AMENDMENT
Reference # 1

ORIGINAL DOCUMENT TITLE: Invitation to Tender for Supply and Installation
Culverts – Harbour Drive, Dunville
Tender # 2022-10-03-001

DATE OF ISSUE: Issued October 5, 2022
SUBMISSION DEADLINE: Closes October 19, 2022 2:00 PM

APPENDIX A Harbour Drive Repairs + upgrades

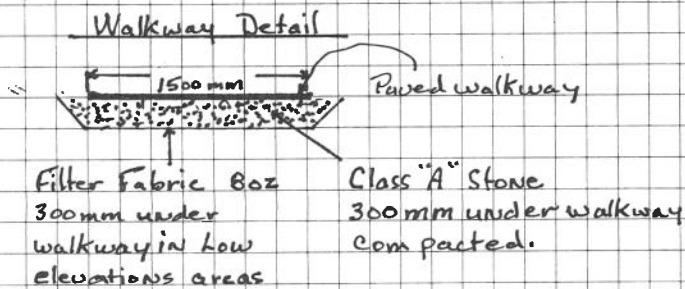
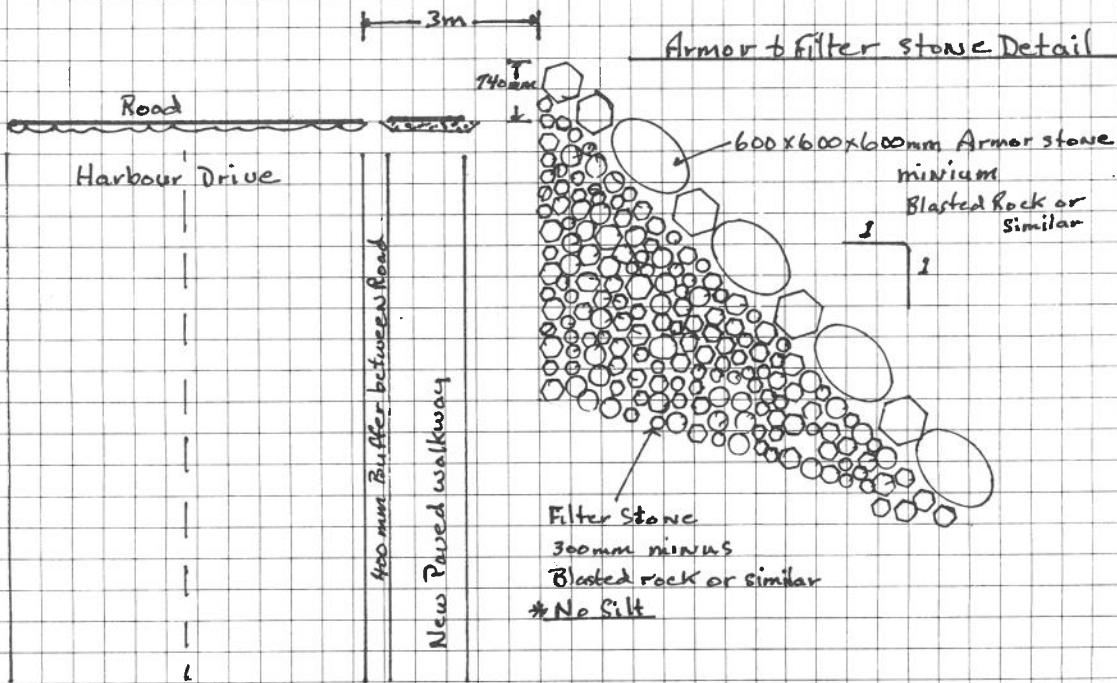
Contractor must add armour stone on the waterfront side for erosion protection.
See detailed drawing – Appendix A attached.

Also, some areas may require sewerage outfall to be extended within 10m of the culvert replacement. Sewer outfall must extend beyond the low tide mark. Contractor must ensure that backfilling material does not damage any of the outfalls and must be large enough to prevent washout.

1. Distance from road to armor stone will be 3m
2. Paved walkway will be 1.5m wide
3. Class "A" stone under walkway will be 300mm compacted before paving
4. Filter fabric under Class "A" stone 220m x 1.0m in Low elevation area
5. All sewer (private) 4" PVC will be extended beyond foot of Armor Stone
6. All culverts will be extended beyond foot of Armor Stone
7. All culverts/sewer lines will be noted on drawings
8. Armor & filter stone will extend 740mm above walkway/road.
